**SITE PLAN**  
 Address: 11556 Highway 94  
 Colorado Springs, CO, 80929

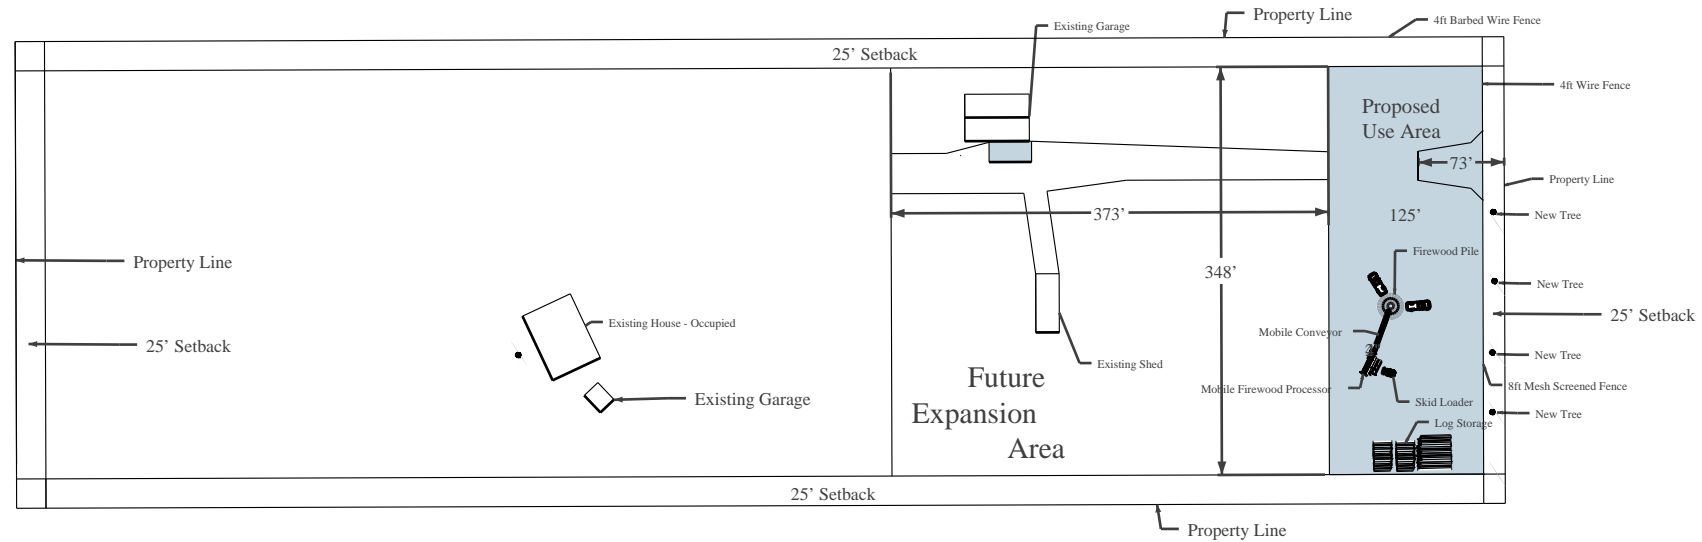
Label any areas of customer parking. If there are areas where customers get out of the car, you might have to offer HC accessible parking as well. Verify with Pike's Peak Building. That level of detail can be worked out at time of site plan but if there is customer parking you should at least generally show location on this exhibit and surfacing material.

The code requires roadway landscaping along 94 (1 tree per 20 feet of road frontage excluding the driveway width)

The code requires buffer and screen areas between non-residential uses and residential zoning districts. A 6' solid opaque fence or wall is required along the lot, parcel, or tract line where non-residential use abuts residential zoning district. Also one tree for each 25 feet of common lot, parcel, or tract line is required.

Will you have office space on-site? If so, where located?

The Code requires areas of outside storage of equipment and/or materials to be screened with solid fencing that is a minimum height of 6 feet. Chain link fencing with screen is not considered solid. Additionally, if you provide a fence taller than 7 feet, it is considered a structure and shall meet setbacks.
